PERFORMANCE UPGRADE UBI-2590

In compliance with new military performance specifications Ultralife have completely upgraded their entire family of UBI-2590 batteries - UBBL02, UBBL10, UBBL10/B and UBBL13. Now designated as the UBI-2590 MGPP line-up, these newly improved batteries can be clearly identified by their added part number suffix, "-01."

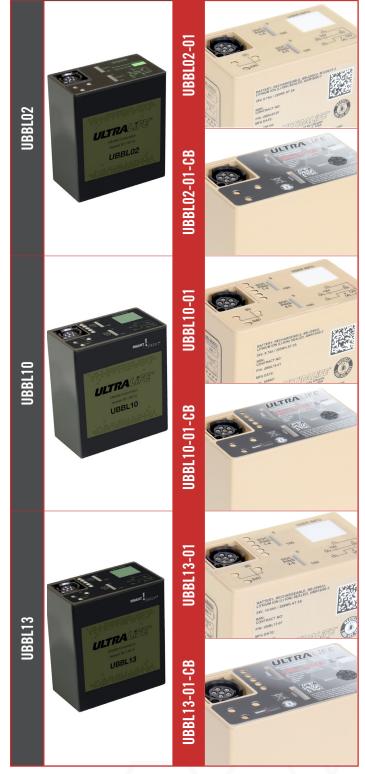
All designed to meet the new MIL-PRF-32383/3(CR) U.S. Military Performance Specification, the new "-01" versions also come with brand new labelling, complete with military mandated text and symbology.

- New case design
- Improved electronics & protection module
- More accurate state-of-charge technology
- Improved cold temperature discharge performance
- Widened charge temperature range
- New color: Desert Tan
- Certified to IEC 62133:2012
